February 22, 2018

Excelsior Mining, February 6, 2018

Technical Memorandum

Review of Underground Injection Control ~~Aquifer Project Permit and Application~~ Gunnison Copper Project

Figure 1: Figure 11 from Attachment A-2 Appendix I showing the regional potentiometric surface. The red boundary line is the bounds of the regional groundwater model.

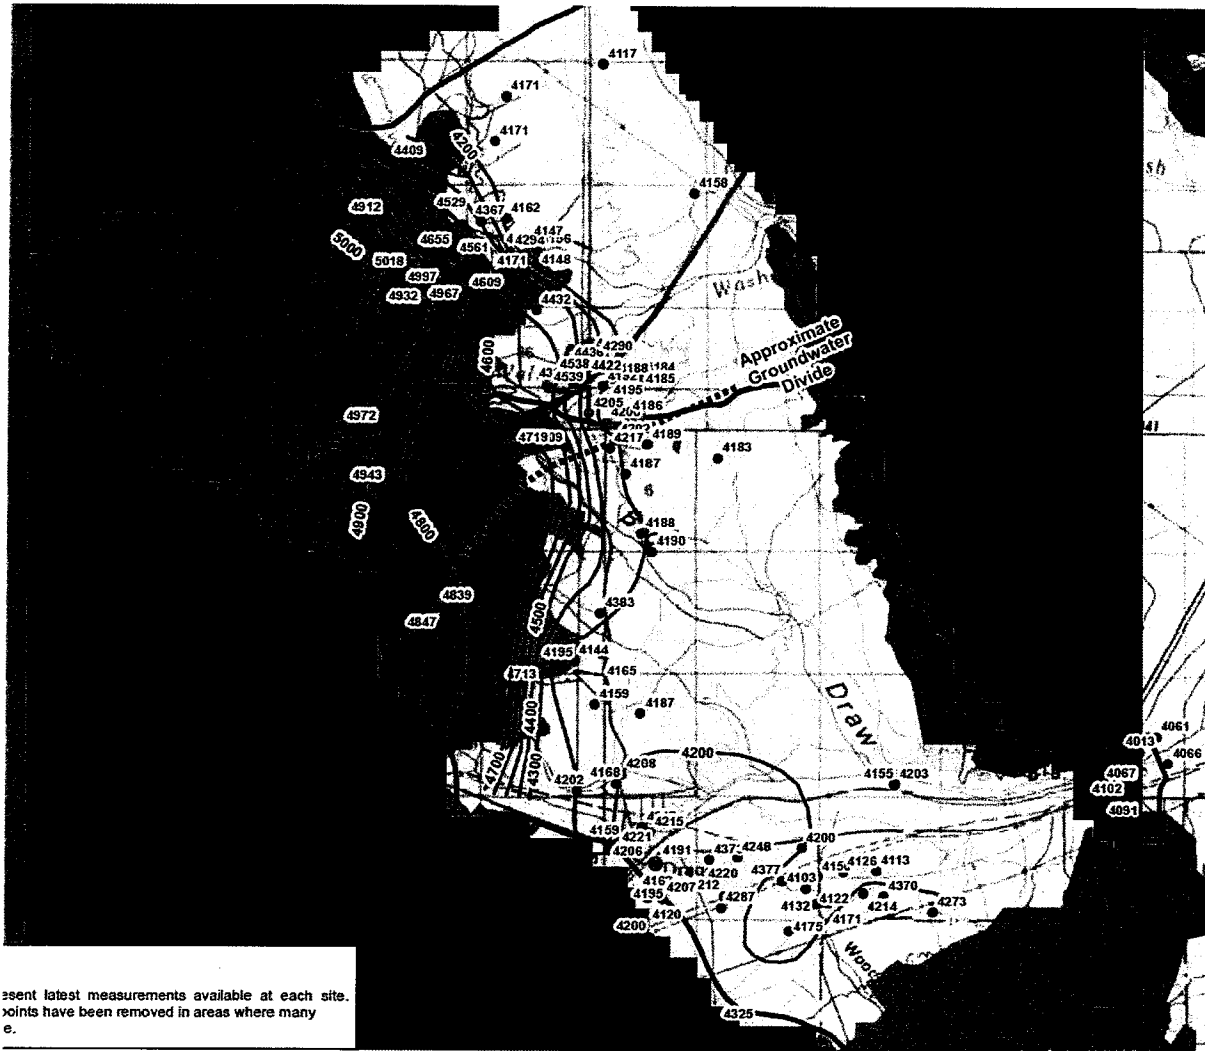
Figure 2, showing more detailed localized groundwater contours, does not replicate the regional divide. Figure 2 contours demonstrate the complexity of groundwater flow through the site.

- See comment above. The groundwater divide is not an element of BADCT for the wellfield nor is it required for or used in the control of solutions and is therefore not relevant.

Figure 43: Figure 123 from CCA (2016) Attachment A-3 Appendix G showing the relation of hydraulic conductivity with azimuth between pumping and observation wells.

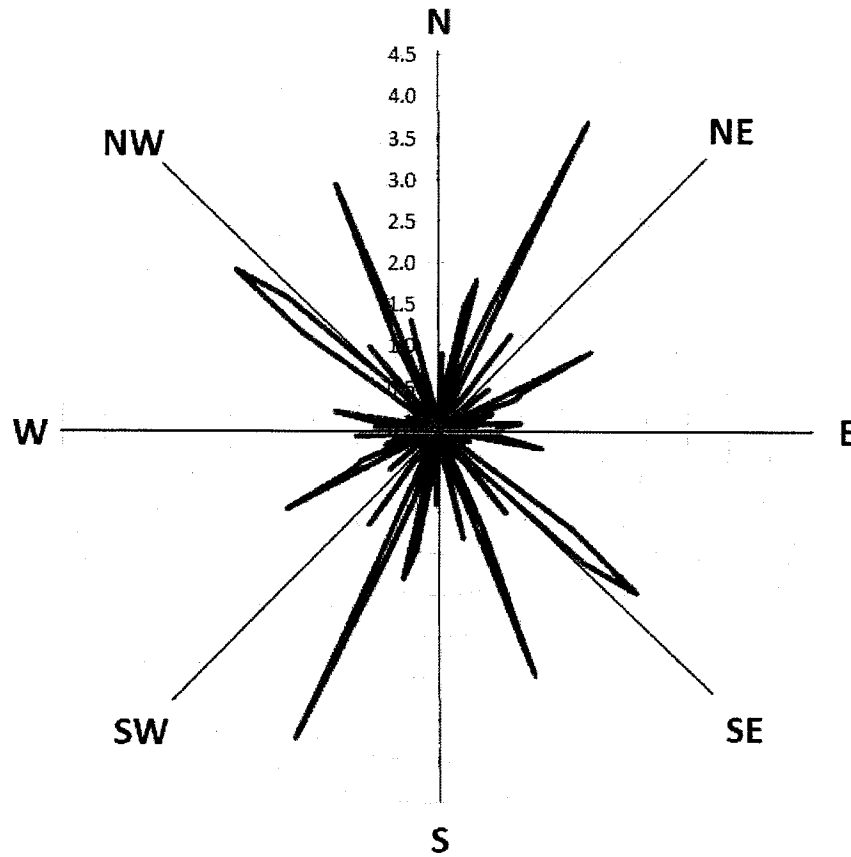
Attachment A-3 Appendix G presents a directional plot of conductivity with azimuth. The plot shows the mean average K values without accounting for direction (Figure 4B). Rather than showing "that the hydraulic conductivities are relatively evenly distributed with little prevalent direction" (Attachment A-3 Appendix G, p. 31), Figure 4B shows a substantial correlation with direction. This is especially true for a direction from midway between north and northeast and between north and southwest, where the K exceed 4.0 ft/d, and for a roughly perpendicular direction along

which K is just over 3.0 ft/d. Additionally, between those transverse K trends, there is another line of about 3.2 ft/d trending from between north and northwest to between south and southeast. K in other directions is less than half as much. The trends show a perpendicular fracture pattern, but does not demonstrate that "the fracture patterns intersect sufficiently at the well spacing of 100 feet to smooth out, for the purpose of hydraulics, discrete fracture spacing which is on the order of one foot" (Attachment A-3 Appendix G, p. 31). There is nothing in the Appendix, or anywhere in the Application, that indicates the spacing of the intersection of fracture patterns or of one foot discrete fracture spacing.

- The comment is incorrect. Heterogeneity is built into the model via the relationship of hydraulic conductivity zones to the geologic model. See ADEQ APP Response #6.2, below and the last response, above. Higher conductivity pathways are included in the groundwater model as higher K zones.

Figure 54: Figure 5-9 from Clear Creek Associates (2017a) showing the wells and coreholes with petroleum hydrocarbon hits.

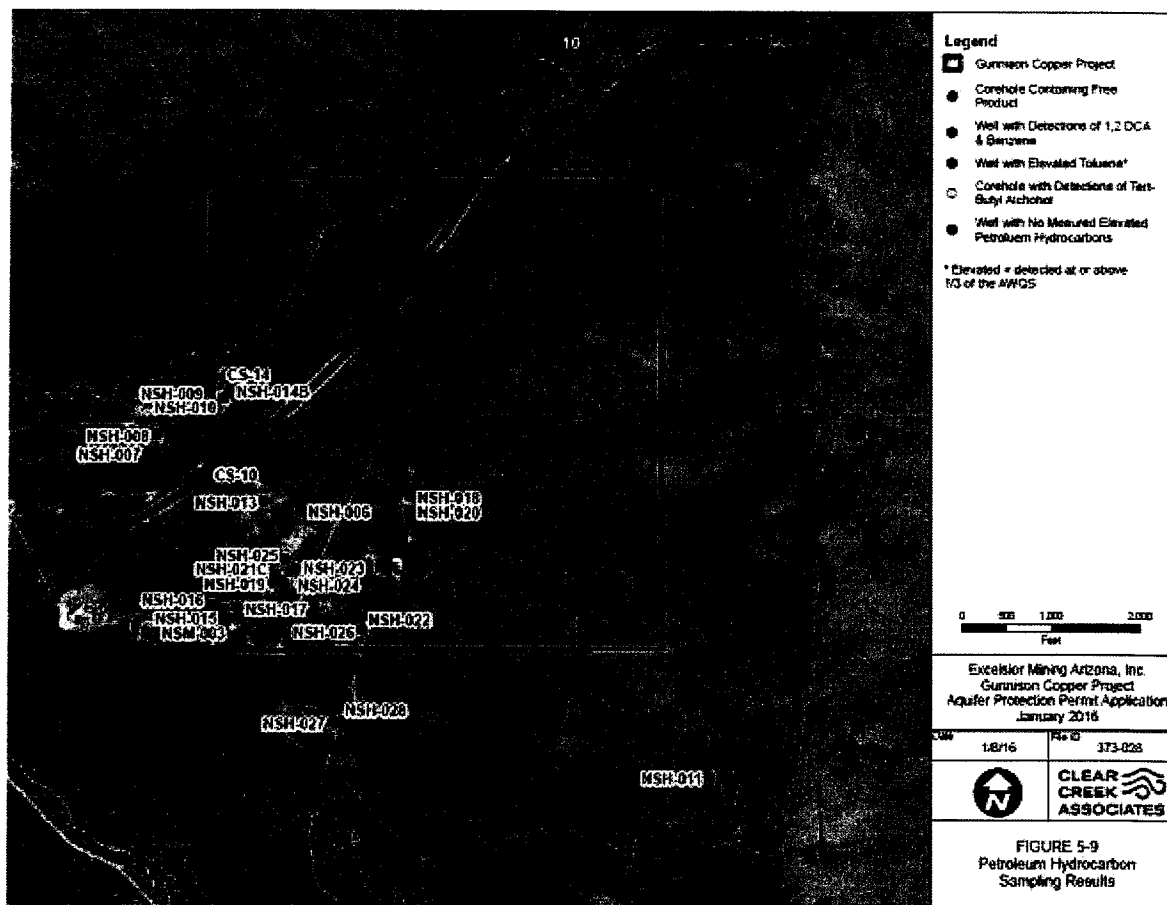
2016, p 5-8). That indicates there is a significant source of LNAPL near the site. The clustering of wells with different hydrocarbons, as seen by the distribution of hydrocarbons in Figure 54, may reflect different transport and attenuation rates for the different products within the fracture zone affected by the source. The intermixed wells without any hits may be screened in different fracture zones.

ADEQ does not consider petroleum hydrocarbons a significant issue to liner performance, SX-EW performance or additional impacts to the aquifer. Based upon Excelsior's response to ADEQ comments in June 17, 2016, the hydrocarbons appear to be related to old drilling methodologies which used petroleum fluids during drilling and residual contamination from the former Leaking Underground Storage Tank (LUST) release from "The Thing" near the southwest corner of the site. Mining will extract any remnant hydrocarbons which will then be processed with the other extracted fluids.

Figure 5: Figure 5-10 from Clear Creek Associates (2016) showing the potentiometric surface at the site and to the west and northwest.

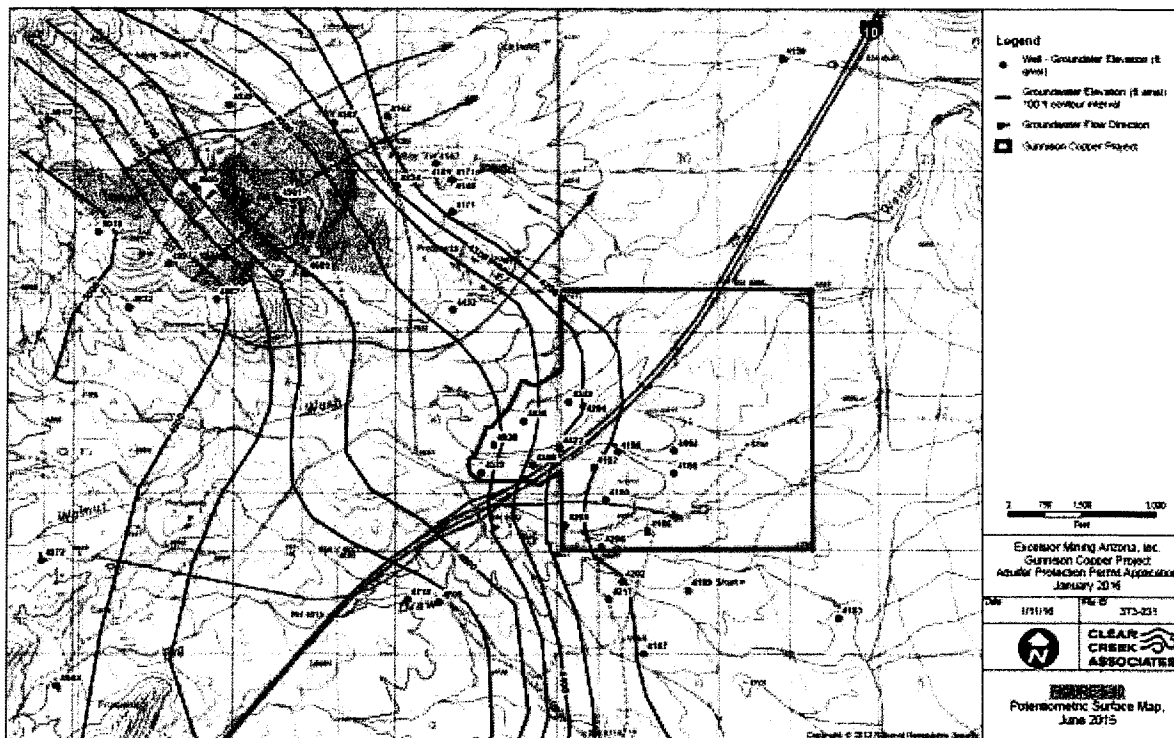
As noted, the mine apparently did not use gasoline, so Excelsior seems convinced that it could not be a source (CCA 2016, p 5-9). They also point to the gradients of the potentiometric surface which suggest that groundwater flow from the mine would be to the northeast and would miss the project site by a mile or more. The potentiometric surface (Figure 25) appears to drop steeply northeast of the mine and appears to form a ridge on the west side of the project site.

- Due to the importance of understanding the source of petroleum products, Excelsior should reconsider the potentiometric surface map to consider whether the water levels used for mapping all represent the same aquifer level. In a fractured rock aquifer, it is not often appropriate to assume there are no vertical gradients. The map with water level with respect to the top of the bedrock (Figure 5-12, CCA 2016a) shows significant variability in small areas, suggesting that it is possible the water levels represent different bedrock levels. It is possible that groundwater flows southeast from the mine at certain levels. For this reason, the mine cannot be ruled out as a source.

*ADEO response to Comment #6.6
Please see response to Comment #6.5*

Figure 7: Figure A-7 migrating away from the draft permit, Appendix A, showing the project area and location of hydraulic control wells, observation wells, and point-of-compliance wells.

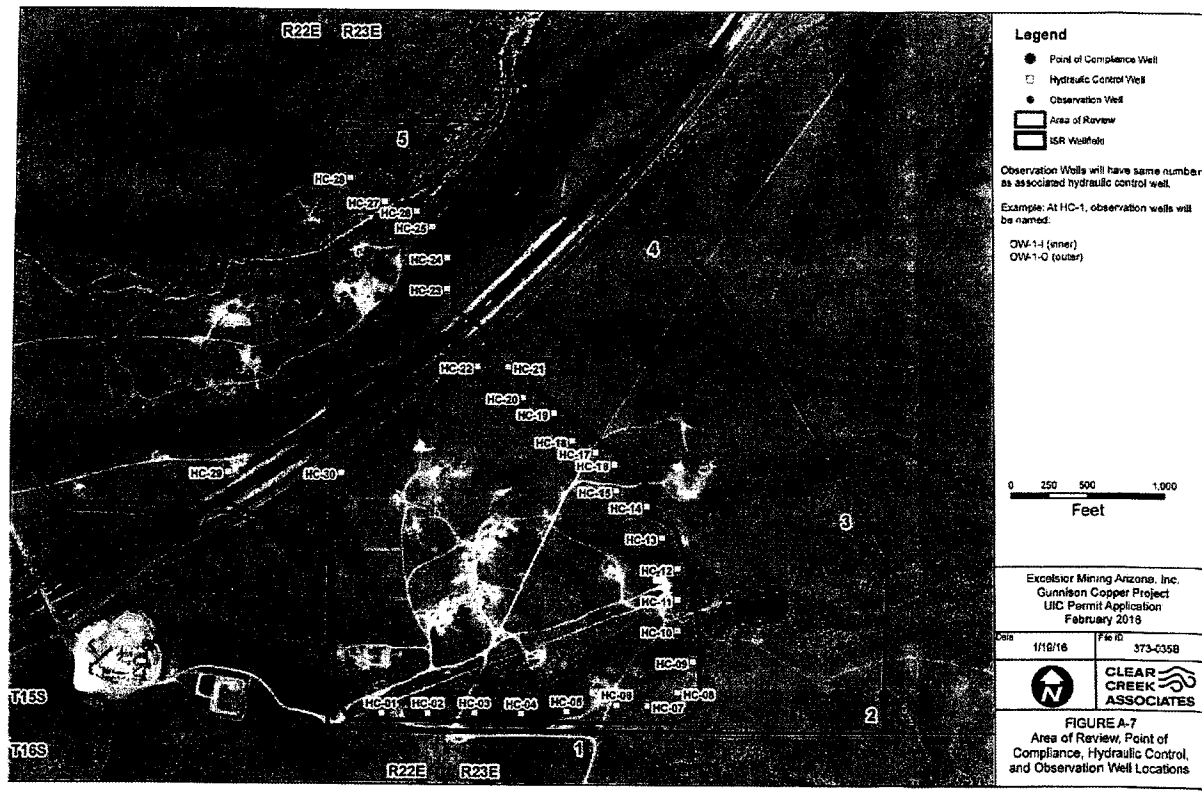
Figure 7, Figure A-7 from the draft permit, shows the HC, IMW, and POC wells for the site. The OW wells show as green circles without labeling; some of them plot underneath the yellow squares showing HC wells, so the figure is not perfectly clear. There are three pairs of OW wells and seven HC wells across the southern boundary of the well field, or about 2000 feet. Most remaining HC wells spread along the east and northeast boundary of the site, about 4000 feet, with two HC wells on the west. There are seven pairs of OW wells on the east and one pair on the west (Figure 7). Not all wells would operate simultaneously, however. Draft permit, Appendix A, Figures A-7a, A-8, and A-13 through A-16, show the monitoring wells as operated for given time periods. The draft permit does not show the monitoring well layout after year 13 (Figure A-16), which is the end of mining stage 2. This is a concern because it is after year 13 that mining stage 3 begins, during which most of the project area is being mined at the same time. With over 25,000 gpm being injected, this would seem to be the most important time period for extensive monitoring.

As described above, there are multiple pathways and scenarios which could lead to contaminants escaping the hydraulic control of the site. The monitoring well scenario described within the draft permit is insufficient to protect offsite resources, including wells near Dragon. This violates requirements for monitoring wells outlined in 40 CFR 146.62(h), which requires spacing based on an assessment of geology.

Figure 8: Portion of Draft Permit, Appendix A, Figure A-13 showing the intermediate and HC monitoring well layout for year 1. the green circles are IMW wells, the triangles are inactive HC wells. The figure shows faults and the project boundary (blue dashed line).

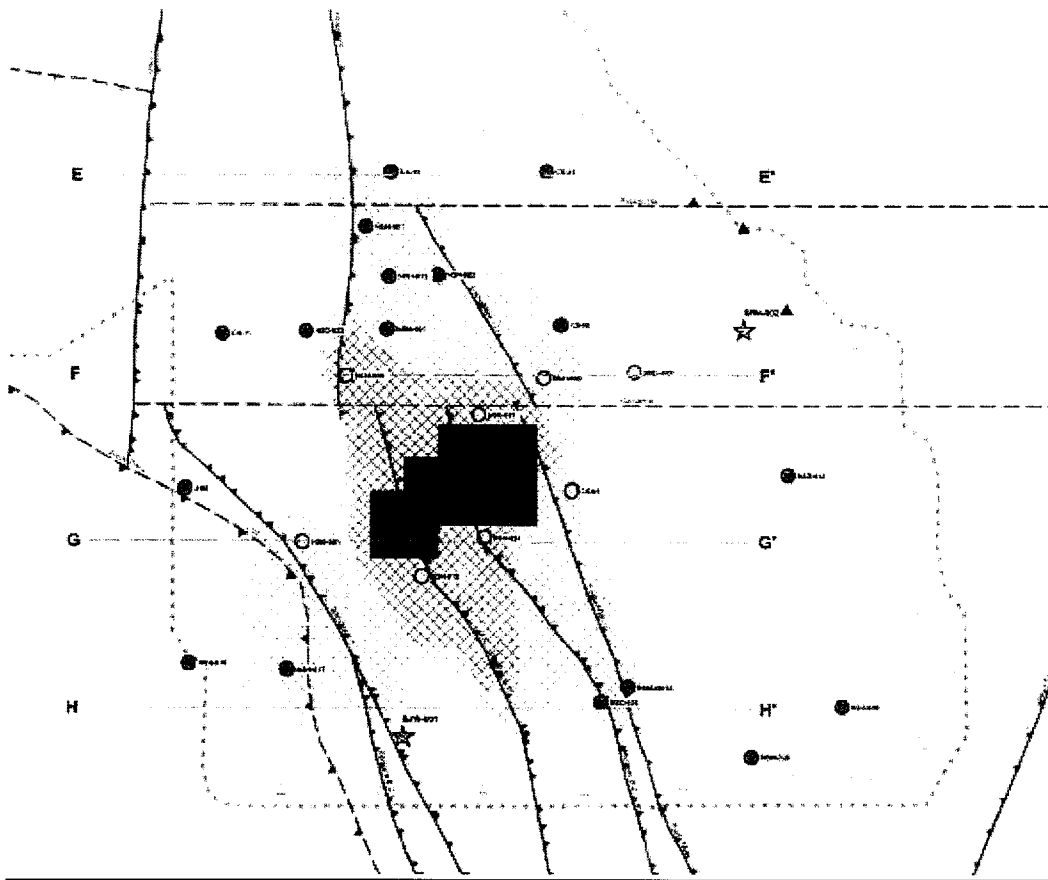
The Draft Permit establishes special consideration for three HC wells established on the southern project boundary prior to year 1 (Draft Permit, p 25). The consideration includes daily monitoring of SC, even though the development is at least 700 feet north of the boundary. This indicates the EPA recognizes the potential for southward flow, but their response is inadequate because the wells would be spaced too widely. Figure A-13 shows the wells well fields and HW wells at year 1 (partially reproduced here as Figure 8). Including at least six faults trending NW-SE. Any of these faults could provide a pathway for contaminants to escape the project site, especially with a pressure boost from injection. The monitoring of this potential threat is grossly insufficient.

- All six faults or potential fluid channels described by Myers above, and depicted in the figure above, are intersected by one or more of the IMW's. These IMW's are therefore well positioned to detect any release of mining fluids from a mining block.

Figure 1312: Figure 32 from CCA (2016) Attachment A-2Appendix I showing the calibrated steady state recharge rates around the model domain.

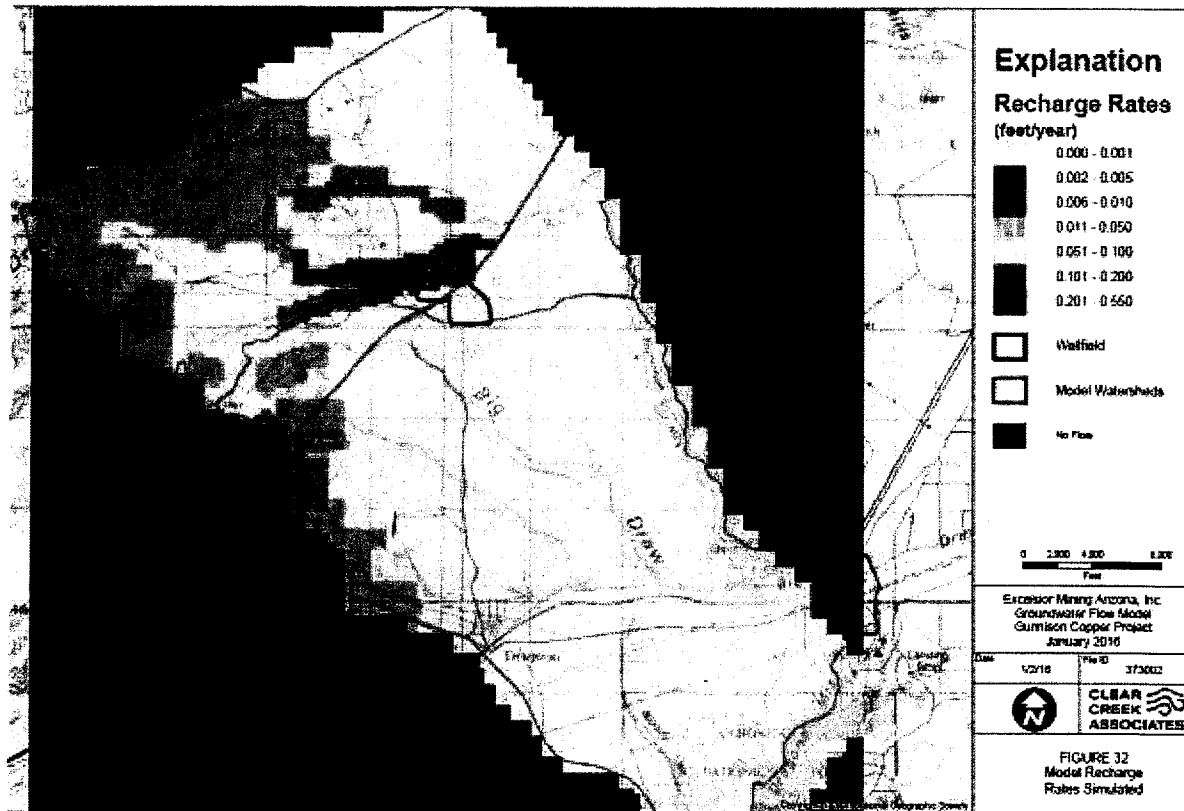
The concentrated recharge may significantly bias the model results. The large zone in orange west of the project site in the Little Dragon Mountains, is recharge from 1.2 to 2.4 in/y (Figure 13-12). Recharge would enter the groundwater in this mountain block only if the geology is highly fractured at the surface; otherwise the area should mostly generate runoff. Much of those mountains have the second highest conductivity values (Figure 14-13), possibly due to the calibration.

Only the smallest recharge rate is used for recharge in the Dragoon Mountains in the southeast. Even if the geology is not conducive to distributed recharge, there should be runoff that leads to mountain-front recharge.

- The Dragoon Mountains and the runoff from them play no role in calibration of the model because Big Draw lies between the Dragoon Mountains and the project site.

Figure 1413: Figure 21 from CCA (2016) Attachment A-2Appendix I showing conductivity in model layer 1, the uppermost layer in the model.

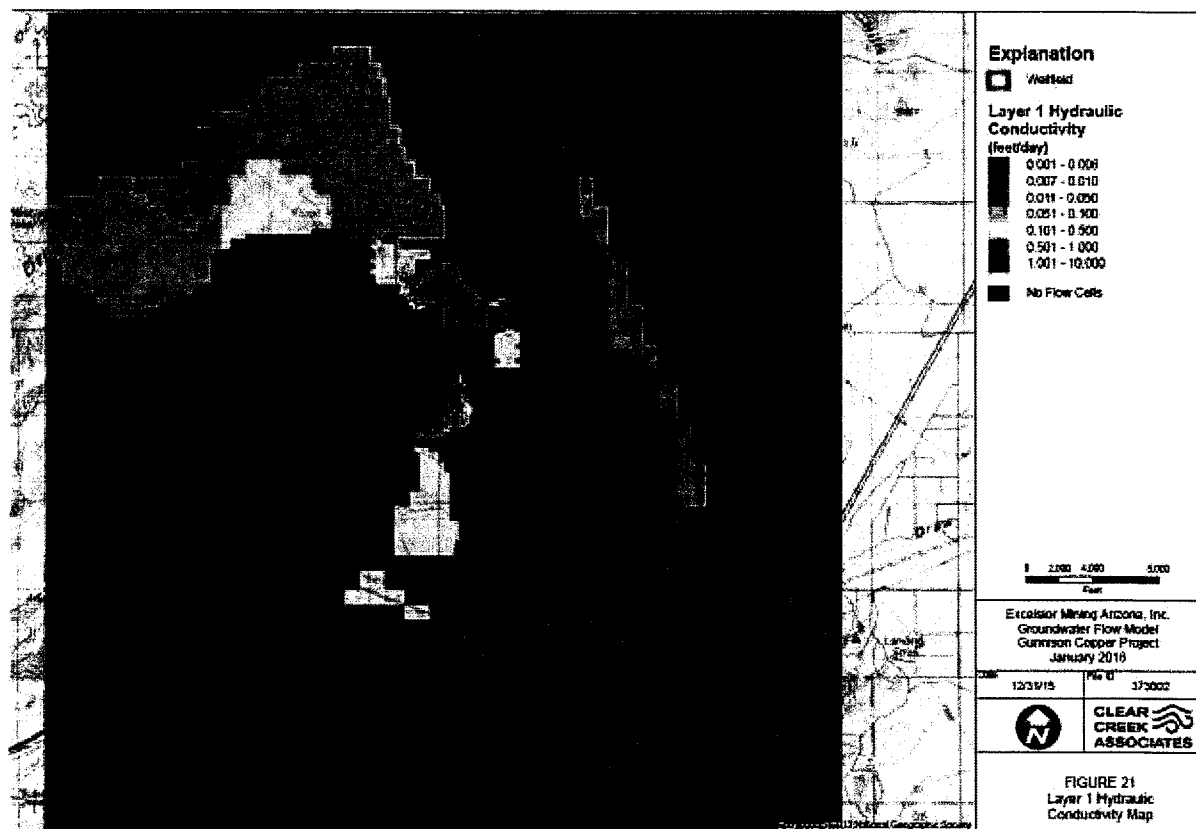
The low K in model layer 1 west of the well field (Figure 1413) coincides with the high recharge in the Walnut Wash (Figure 13). 12. This causes the higher groundwater ridge and steep slopes seen in the modeled steady state contours (Figure 1514). Much of the remainder of the high recharge zones west of the project coincides with higher conductivity material in layer 1.

- Basin fill material has much higher conductivity than bedrock. This has been well documented throughout the state of Arizona. Obviously, Walnut Wash extends over bedrock at the base of the Little Dagon Mountains to higher K basin fill to the east. Although there is a general paucity of data in the basin fill just east of the project site, it is certainly reasonable to assume the hydraulic gradient flattens where the groundwater table encounters basin fill.
